**AGENDA**  
**LANDMARK COMMISSION**  
**REGULAR MEETING**  
**4:00 p.m. Monday, August 3, 2020**  
**City Council Chambers, 2<sup>nd</sup> Floor of City Hall**  
**823 Rosenberg, Galveston, Texas**

# 20LC-057

## 20LC-058

Request for a Certificate of Appropriateness for alterations to the structure including modifications of the rear façade of the house, the accessory structure, and the addition of a metal shingle roofing.

- A – Current Door
- B – Proposed Door

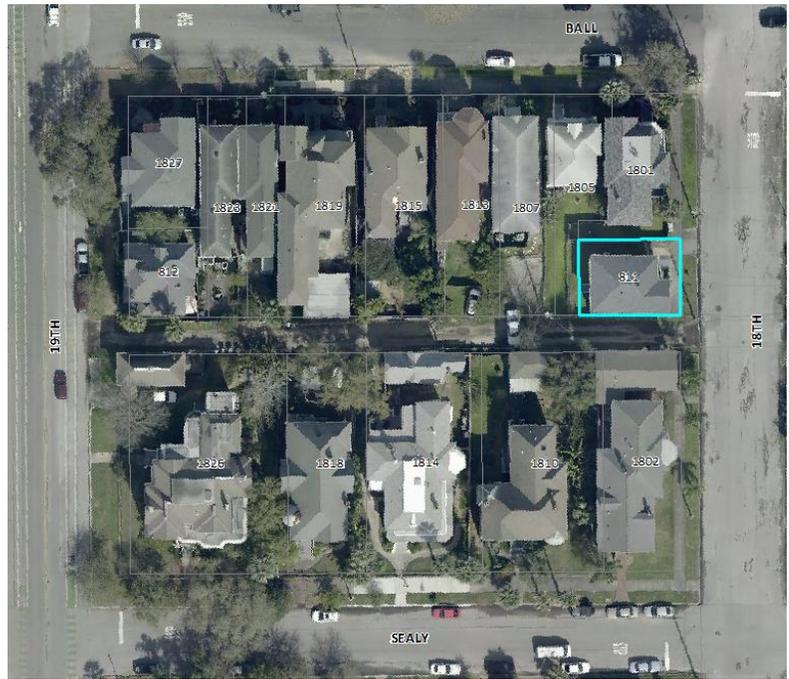
Staff finds that the request generally conforms to the *Design Standards for Historic Properties*. The existing door is not original and the proposed door is appropriate for the age and style of this house.

1. The applicant shall conform to the design, material, and placement shown in Attachment B of the staff report;

# ATTACHMENT A

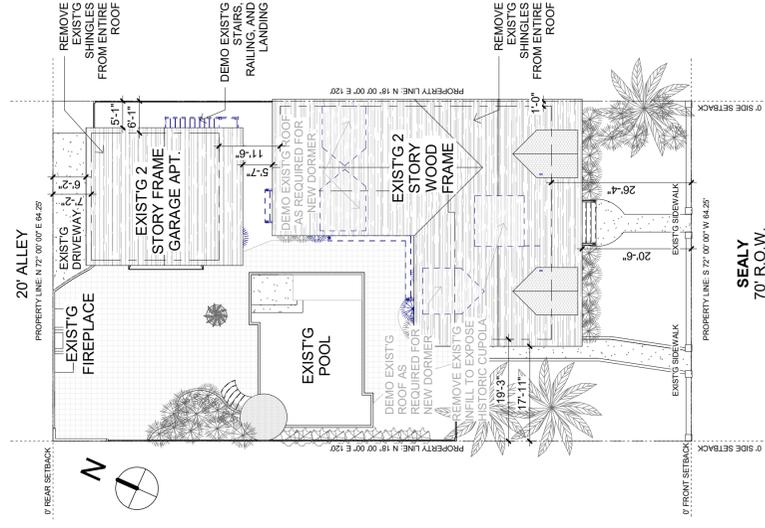
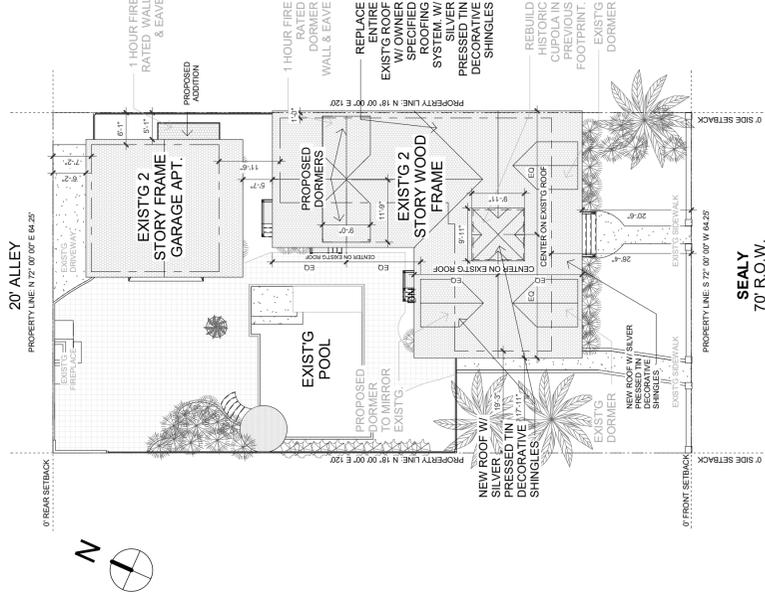
The existing garage apartment is not historic. None of the proposed changes to this structure are contrary to the Design Standards, nor will they adversely affect the character of the historic main structure or surrounding properties. Generally speaking, these are not easily visible from the rear alley or from Sealy/ Avenue I.

Similarly, the additional changes requested under case 20LC-058 are in Location D: Not Typically Visible Rear Façade. More flexibility in treatment may be considered, especially for compatible replacement or alteration that is not visible from the street.

The applicant did not provide cut sheets for the windows, doors, or garage door, but the architectural drawings call for salvaged and relocated existing windows. Assuming these are wood, these changes are generally in conformance with the Design Standards. Screening in the existing porches is also permissible, as this will be accomplished by use of treated wood frames to hold the screening, installed between

the existing porch columns. Finally, Sanborn insurance maps indicate that the roofing was non-combustible as of 1947, which includes metal and tile roofing; however, historic roofing material remains unknown. Metal shingle roofing was known in the United States as early as the late 1850s, so it is possible that the house featured a metal shingle roofing at some point in time.

- 1) The applicant shall conform to the design, material, and placement shown in Attachment A of the staff report, with the following modifications:
  - a. The salvaged windows shall be approved by the Planning and Development Division prior to installation;
  - b. Existing windows that are removed shall be reused if possible, or retained on site;
